Nebraska Public Power District
Nebraska's Energy Leader

NLS2002093
December 19, 2002

Subject: Additional Information Related to License
Condition 2.C.(6) Seismic Evaluation
Cooper Nuclear Station
NRC Docket No. 50-298, DPR-46

DESIGN NUMBER	DATE	BY	DATE
GROUP	RA/KJD	10/18/02	
	CHECKED	DATE	
	RLY	10/18/02	
	APPROVED	DATE	
	TDS	10/28/02	
<p style="text-align: center;">LEAKAGE PATHS FROM OUTBOARD MSIV's COOPER NUCLEAR STATION</p>		<p style="text-align: center;">N Nebraska Public Power District</p>	<p style="text-align: center;">CNS-MS-43</p>
		REVISION	NO. FILE
		4	CNS-MS-43

ENCLOSURE 1

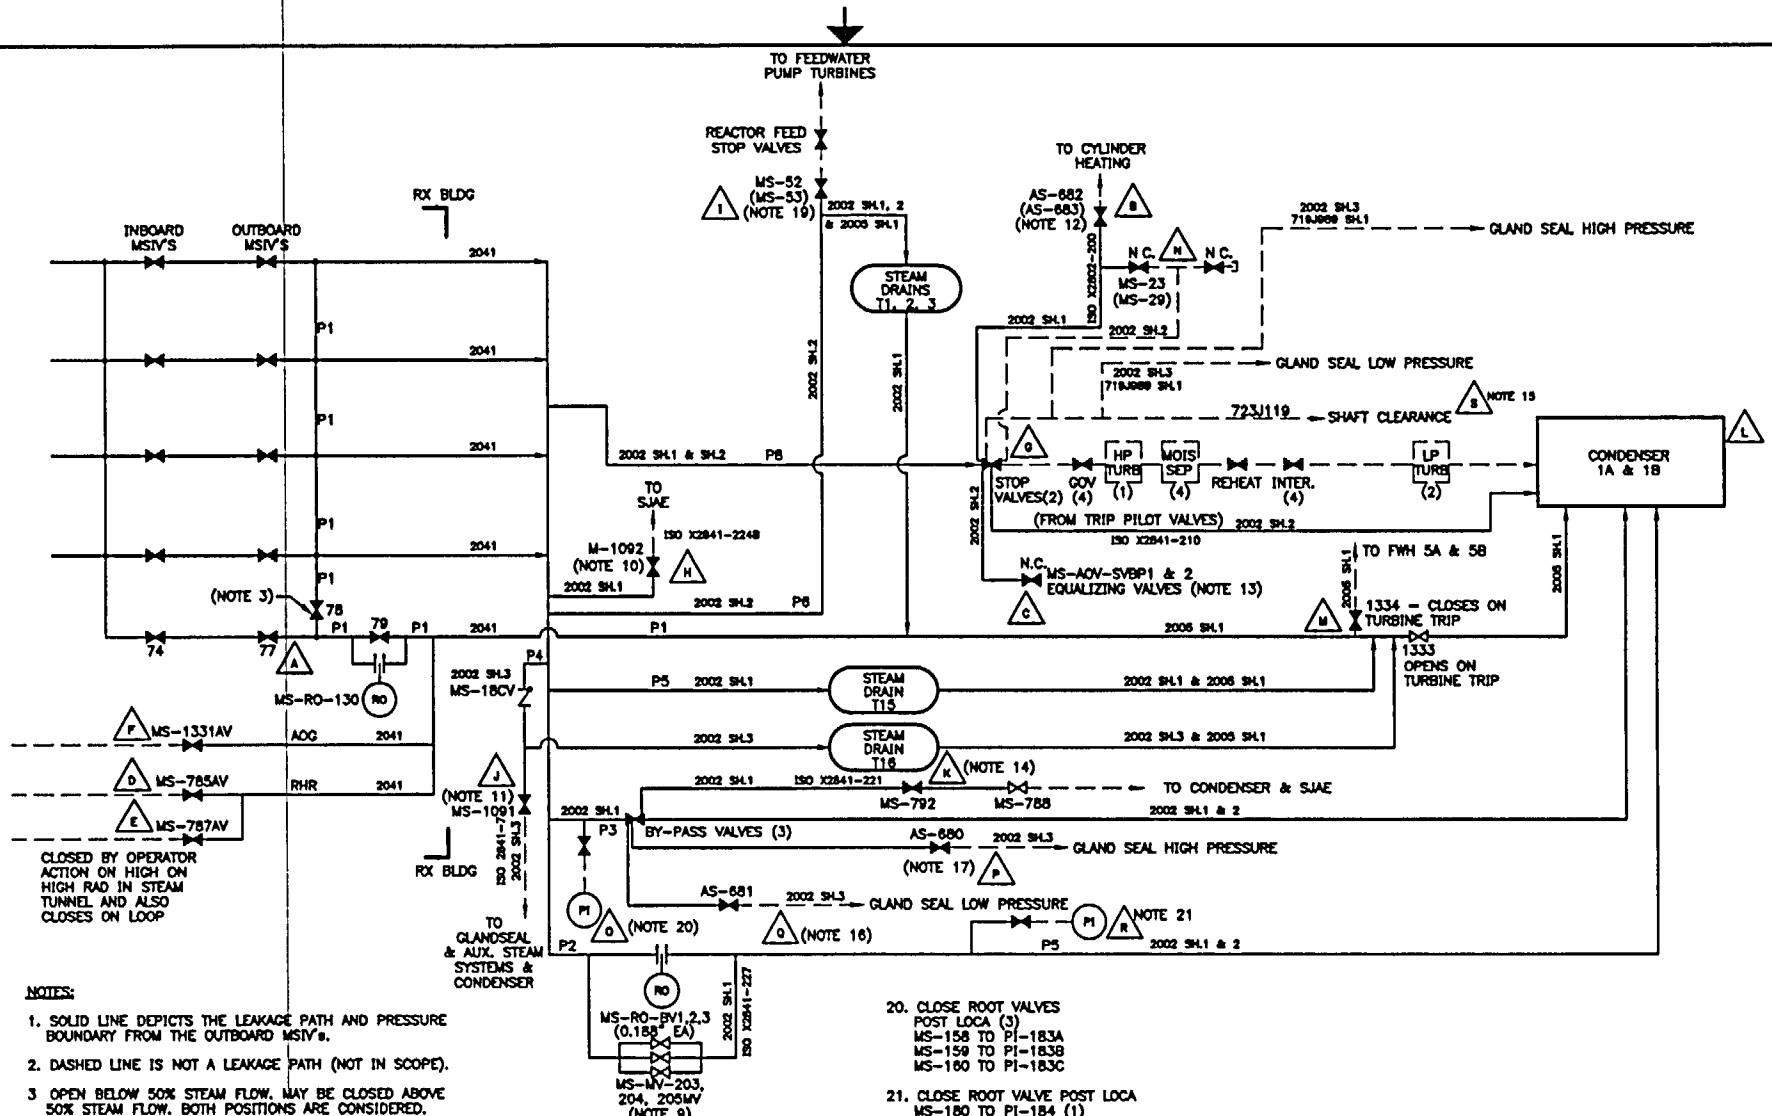
The final configuration of the MSIV leakage pathway is as shown on Enclosure 1. This drawing replaces the one provided in Enclosure 1 to Reference 1, and depicts the pathway piping and boundary valves (including those yet to be installed). Reference 1 described two options being pursued to direct the MSIV leakage to the Main Turbine Condenser. The principal underlying purpose for both of those options was to provide assurance that leakage outside of the MSIV leakage pathway boundary via the Turbine Stop Valve shaft leakage area would be minimized, as discussed in Appendix C to NEDC-31858P Revision 2, "BWROG Report for Increasing MSIV Leakage Rate Limits and Elimination of Leakage Control Systems." After due consideration, the Nebraska Public Power District (NPPD) has decided on a better course of action. The cross-sectional leakage area is being reduced by mechanically adjusting the Stop Valve actuator/control shaft positions through use of a special pre-staged tool, applied as a post-Loss of Coolant Accident manual action.
